INITIAL FIRE SAFETY INSPECTION REPORT

Hamza Textiles Ltd.

RSC ID: 10777

Date: 29-January-2025

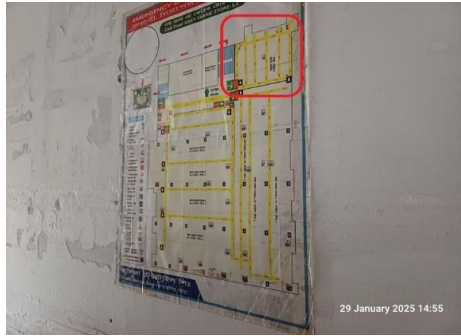
F-4	Fire Rated Construction	The structure (Building-1 & 2) did not have proper distance or separation from adjacent structures (at west, Mymun textile shed; at east DB Tex shed and acid wash shed; at south boundary) as per BNBC Part 3 Table 3.2.2	All existing buildings and structures shall be separated from other buildings in accordance with BNBC 2006 Part 3 Table 3.2.2 and BNBC 2006 Part 3 Section 2.4.1.3.	Within 3 months

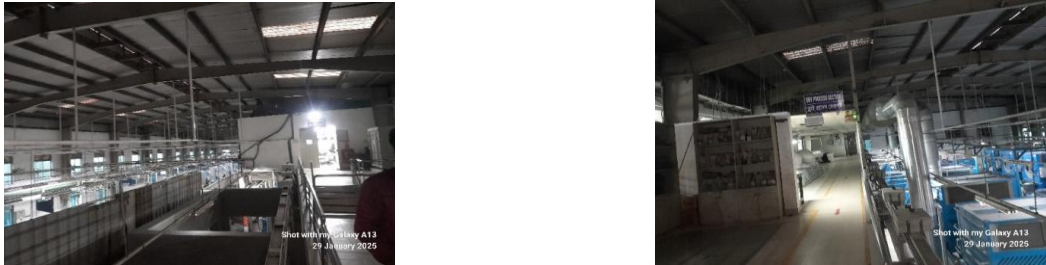
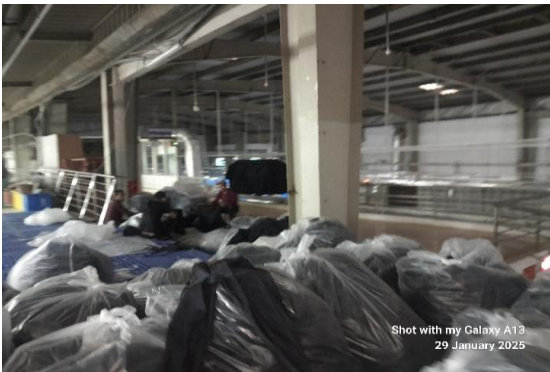
F-18	Means of Egress	Directional signs are not provided where direction of the path of travel to an exit has changed. Location: Building-1 & 2	Illuminated directional signs shall be provided where there is a change in the direction for the path of travel and the direction to an exit is not obvious.	Within 1 month
F-19	Means of Egress	Based on the number and location of emergency lights observed, adequate illumination levels are not anticipated along egress routes. Location: Building-1 & 2	Test the emergency lighting system on each floor and provide additional emergency fixtures to supply adequate illumination along the means of egress. Provide a minimum illumination of 10 lux at the floor level within exit stairs and along exit discharge paths and a minimum 2.5 lux along exit access aisles	Within 1 month
F-20	Means of Egress	Manual on-off switch is provided for exit signage and emergency lighting system throughout the building. Location: Building-1 & 2	Remove manual on/off switches from exit signage units to prevent them from being switched off.	Within 1 month

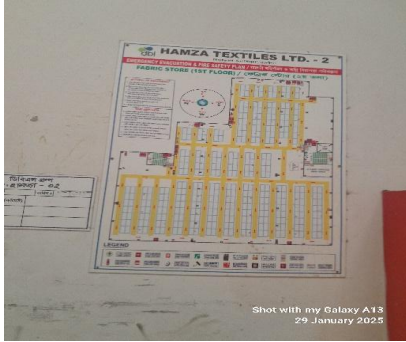
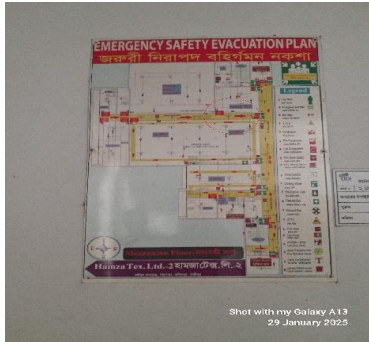
F-38	Means of Egress	Directional signs are not provided where direction of the path of travel to an exit has changed. Location: Building-3.	Illuminated directional signs shall be provided where there is a change in the direction for the path of travel and the direction to an exit is not obvious.	Within 1 month
F-39	Means of Egress	Based on the number and location of emergency lights observed, adequate illumination levels are not anticipated along egress routes. Location: Building-3.	Test the emergency lighting system on each floor and provide additional emergency fixtures to supply adequate illumination along the means of egress. Provide a minimum illumination of 10 lux at the floor level within exit stairs and along exit discharge paths and a minimum 2.5 lux along exit access aisles	Within 1 month
F-40	Fire Alarm & Detection System (FADS)	Fire alarm and detection system installation complete which requires detailed review to confirm compliance with NFPA 72 and RSC Technical Guidelines (Standard). Location: Building-3.	Submit proposed the fire alarm system & detection system design to RSC for initial review. Once the design is reviewed, install the fire detection and alarm system throughout the buildings in accordance with review comment, RSC Technical Guidelines (Standard) and NFPA 72. After installation the factory shall conduct internal testing and commissioning and then contact the RSC for witness of final acceptance testing. Also inspect, test and maintain the fire alarm system, and keep written records on-site, in accordance with Table-14.3.1 of NFPA 72.	Design Review within 2 months and installation/modification within 4 months..

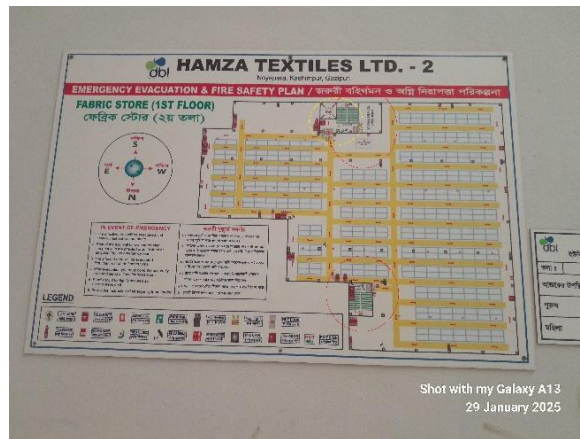
F-45	Fire Rated Construction	Dedicated store room is not separated by fire rated construction due to unprotected opening & penetration. Location: Basement floor & warehouse store room at ground floor of the building-6(HTL-2 production)	Separate the dedicated store room from the surrounding occupancy with a minimum 1 hour fire rated construction.	Within 3 months

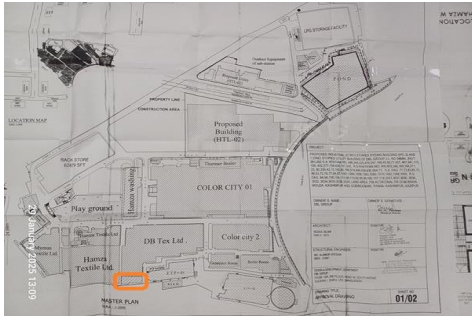
F-57	Means of egress	Exit stairs do not discharge directly to the outside due to civil construction work ongoing Location: S-E side exit stair discharge of the building-6(HTL-2 production)	Modify stair to discharge directly outside. Or, Provide 2-hr fire-rated exit passageway leading directly outside (vestibules to separate any storage areas).	Within 3 months

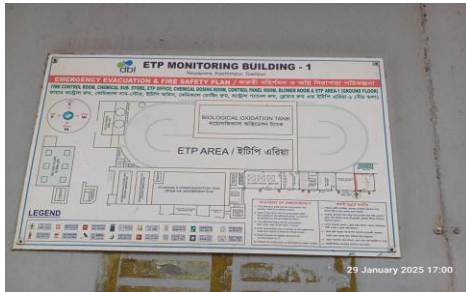
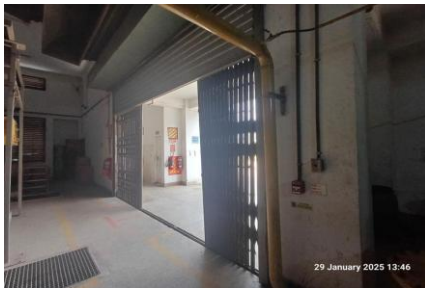
F-65	ITM Emergency Lighting	Inspection, testing and maintenance for the emergency lighting system was not in accordance with The RSC Technical Guidelines (Standard). (For Building-6)	Inspect, test and maintain the emergency lighting system in the accordance with The RSC standard. Keep written records on-site.	Within 1 Month
F-66	ITM extinguisher	Inspection, testing and maintenance of portable fire extinguishers is not in accordance with NFPA 10. (For Building-6)	Inspect, test and maintain the portable fire extinguishers and keep written records onsite, in accordance with NFPA 10.	Within 1 month
